Access Compliance Report

Public Rights-of-Way

Intersection ID: N/A	Main Street: YORK_CENTER	Cross Street: N/A	Location: SE
ADA ID: EEC3DD1EEA42	Ramp Type: PerpDiag	Initial Pass/Fail: Fail	Overall Compliance: No
Codes/Mitigation Info/Possible Solution		Field Measurements/Component Compliance	
Severity Score: 10

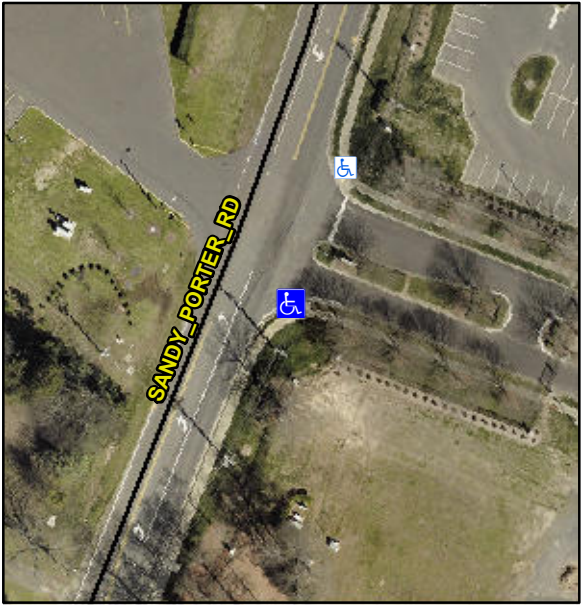
Possible Solutions:	Compliance	Description	Data	Compliance	Description	Data
	Remove & Replace Curb Ramp With Two New Directional Ramps or Equivalent.	N/A	Ramp Length (in)	72.0	Yes	Ramp Slope (%)	6.4
		No	Ramp Width (in)	39.0	No	Ramp XSlope (%)	2.7
		N/A	Flare Type LT	N/A	N/A	Flare Type RT	N/A
		N/A	Flare Slope LT (%)	N/A	N/A	Flare Slope RT (%)	N/A
		N/A	Flare Traversable LT?	N/A	N/A	Flare Traversable RT?	N/A
		N/A	Landing Length (in)	N/A	N/A	DWS Provided?	N/A
		N/A	Landing Width (in)	N/A	N/A	DWS Contrast?	N/A
		N/A	Landing Slope (%)	N/A	N/A	DWS Length (in)	N/A
		N/A	Landing X Slope (%)	N/A	N/A	DWS Full Width?	N/A
<p>Surveyor Notes:</p> <p>N/A</p> <p>PROW/ADA:</p> <p>Not Found, R304.5.1, R304.5.3</p>		N/A	Landing Curb? (Y/N)	N/A	N/A	DWS Offset (in)	N/A
		N/A	Shared Landing?	N/A			
		N/A	Gutter Ponding?	N/A	N/A	Gutter Slope (%)	N/A
		N/A	Gutter Lip Ht (in)	N/A	N/A	Gutter X Slope (%)	N/A
		N/A	Painted X Walk1?	No	N/A	Painted X Walk2?	No
